**Z22-24**  
**Hotel Redevelopment**  
**REVISED**

Property Owner: Legacy Hotel of Medina LLC  
Applicant: Jim Gerspacher  
Location: 253 and 257 South Court Street  
Zoning: C-2 (Central Business)  
Request: Revisions to an Area Variance to Sections 1135.06 regarding maximum building footprint and minimum front setback, 1135.08(a) regarding the location of parking in the front yard, and 1135.13(b)(4) regarding the division of the building into storefronts and a new Area Variance request to Section 1135.06 regarding maximum building height

The current application revises the footprint and height of the hotel building, updates building elevations, and provides greater detail. In addition, the proposed hotel incorporates a first floor restaurant, four stories of hotel rooms, a partial fifth story with a rooftop lounge, and a small one-story area located at the rear of the building for deliveries. The proposed revision does not alter the previous approval of Z24-08.

**1** ELEVATION HOTEL - WEST ELEVATION  
1" = 10'-0"

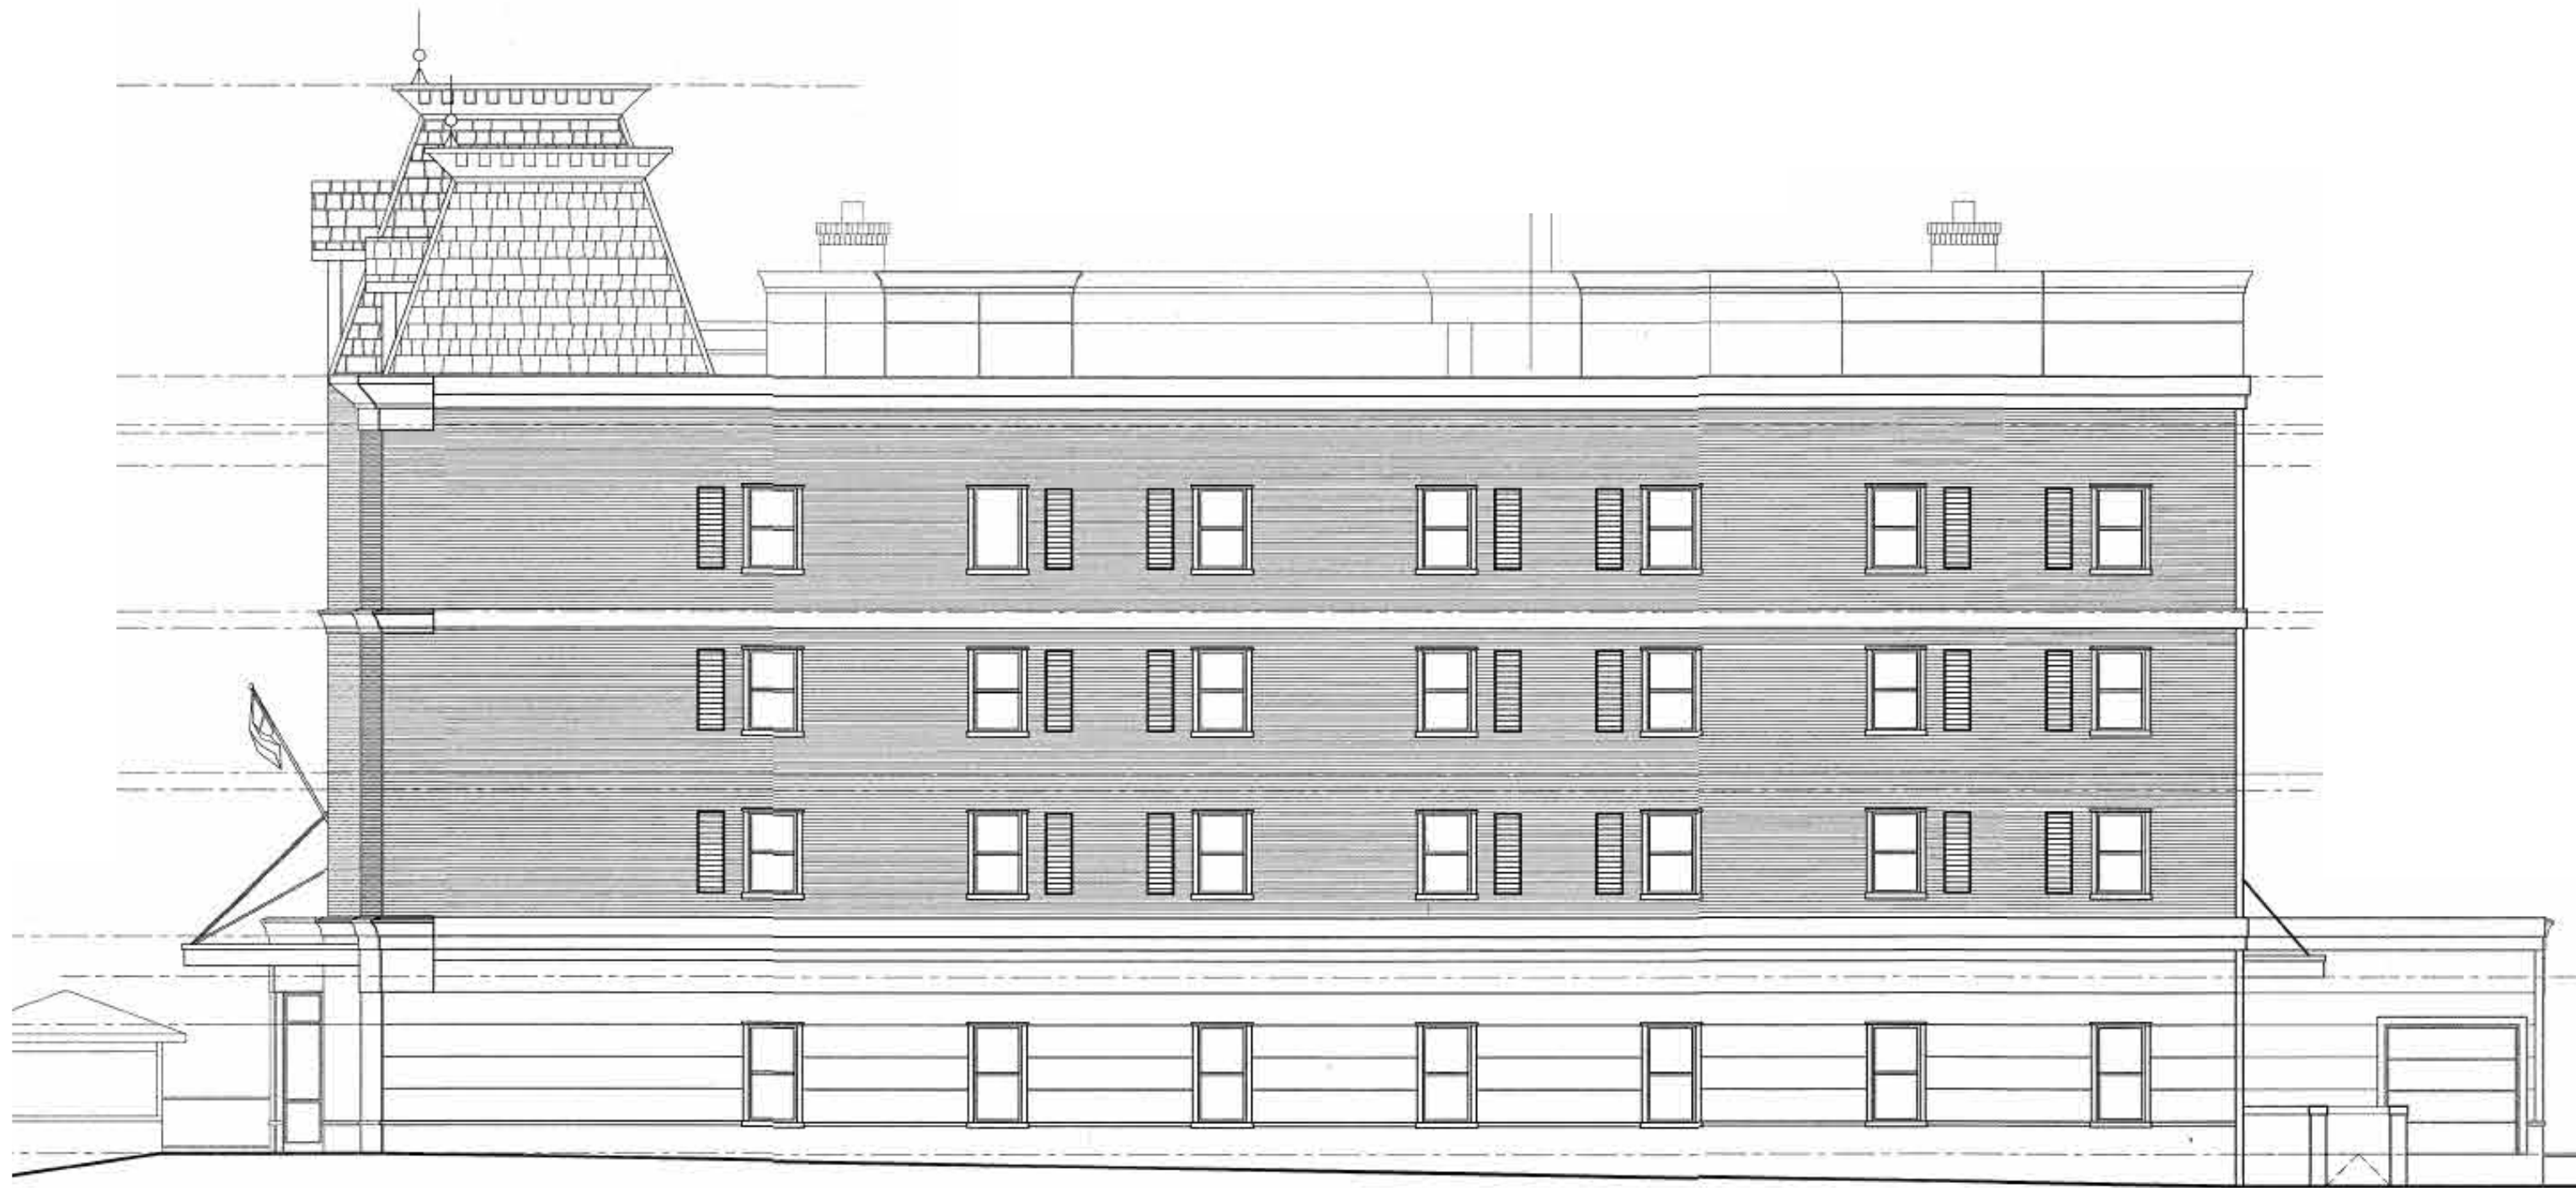
The applicant has provided a contrast between the approved and proposed building heights, particularly on “Hotel – Original East Exterior Elevation” and “Hotel – Original East Exterior Elevation” pages. In addition, the “South East Corner – 3D Street Perspective” page illustrates that the proposed hotel building is located 3 ft. 6 in. lower in grade than the building to the north.

**1 PLAN** ROOF PLAN OUTLINE AND HEIGHTS  
1" = 20'-0"

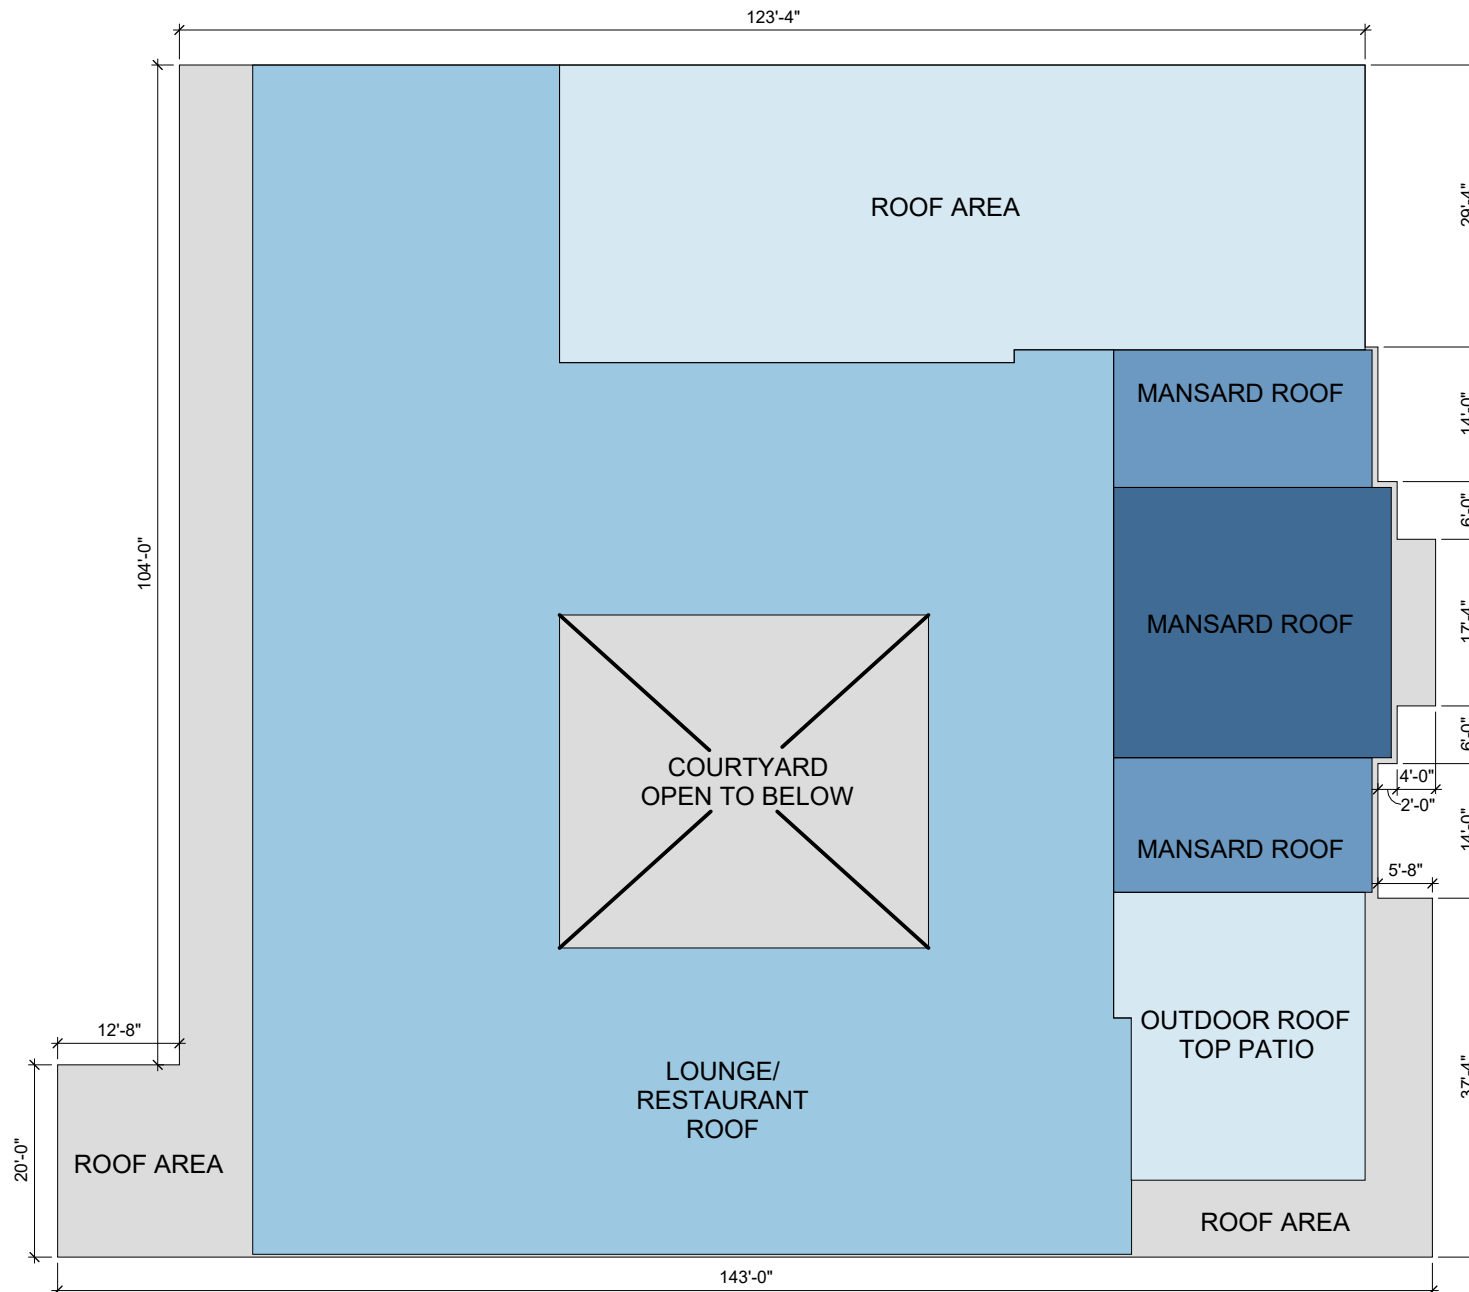
- 2- Height increase: the original approved elevations show the top of roof at 55'-0", the updated drawings show 61'-0". The additional height requested is 6'-0" higher than the previously approved plans. This increase in floor height accommodates more advanced HVAC systems than previously approved without sacrificing quality of interior spaces. Unlike the previous design, no suites will have exterior louvered grilles on the newly proposed plans. Without the new height variance, the available methods of construction are narrowed to options that are not as feasible and accommodating mechanical duct work becomes difficult.
